Australian
Institute of
Architects

Disability (Access
to Premises –
Buildings)
Standards 2009

Submission to
House Standing
Committee on Legal and
Constitutional Affairs

April 2009

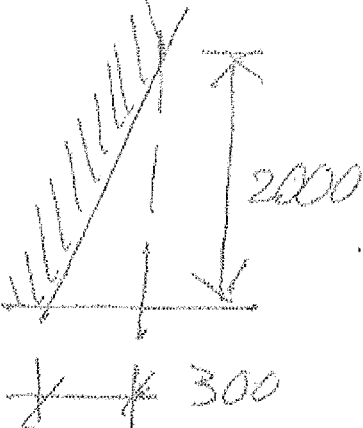
14 Doorways, Doors and Circulation Space at Doorways	Figure 32 Door approach	<p>There appears to be reference errors.</p> <p><u>Proposed amendment</u></p> <p>Amend</p> <p>Line 1: "Figure 31(d)"</p> <p>Line 2: "Figure 31(a), (b), (c)"</p>
14 Doorways, Doors and Circulation Space at Doorways	Clause 14.4.4 Automatic doors	<p><u>Proposed amendment</u></p> <p>Change "automatic doors" to powered doors.</p> <p>Add</p> <p>Where a sliding door is powered, and the approach is from the front, circulation space at WL is not required. [See Figure 31(d)]</p> <p>Amend</p> <p>"For location of manual controls for powered doors, see Clause 14.6.3."</p>
14 Doorways, Doors and Circulation Space at Doorways	Figure 34(c)	<p><u>Proposed amendment</u></p> <p>Amend</p> <p>Show dimension as clear dimension between back of handle and face of door, consistent with Figure 34(b).</p>

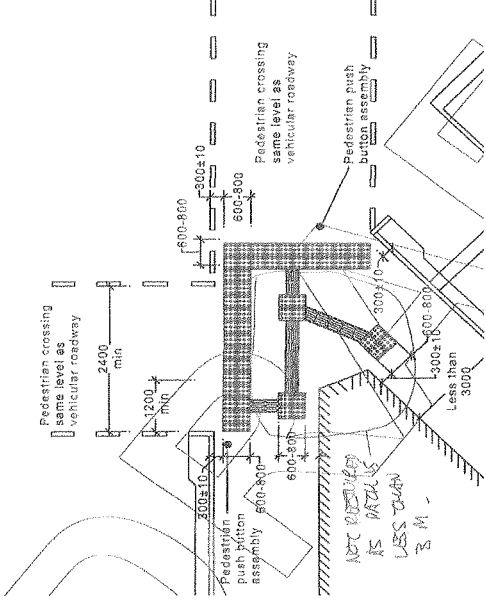
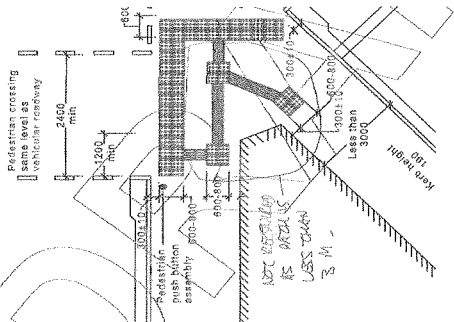
16 Sanitary Facilities	Clause 16.4.1 Paragraph 1	<p>At least one mirror must be provided.</p> <p><u>Proposed amendment</u></p> <p>Delete "where provided" from paragraph 1.</p> <p>Change text in 2nd sentence.</p> <p>"A vertical mirror with finished floor. Alternatively, a vertical mirror with a reflective surface not less than 350mm wide, shall extend from of the finished floor."</p> <p>Add</p> <p>In all sanitary facilities, the mirror shall be located either above or adjacent to the washbasin.</p>

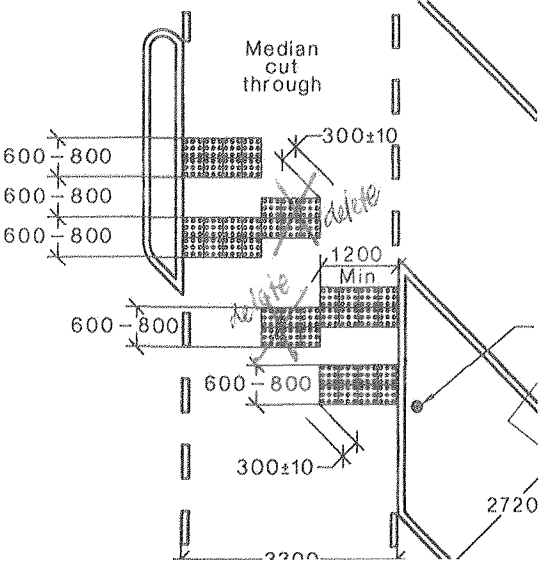
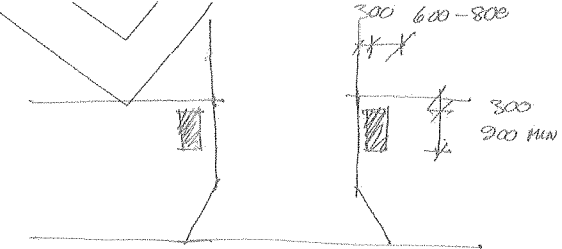
16 Sanitary Facilities	Clause 16.5.6	<p>In a facility shared with ambulant users, the shower head is frequently left in a position higher than 1350mm a.f.l.</p> <p>A product exists that allows the shower head holder to be pulled down from a seated position.</p> <p><u>Proposed amendment</u></p> <p>Add</p> <p>(d) Allow the shower head holder to be pulled down from a seated position by means of a lever or the like.</p>
16 Sanitary Facilities	Figure 51(b) Figure 53	<p><u>Proposed amendment</u></p> <p>Amend</p> <p>Centreline of WC pan: "450 to 460" Centreline of wash basin: "425 min."</p> <p>Add</p> <p>Dimensions to locate the coat hooks.</p>
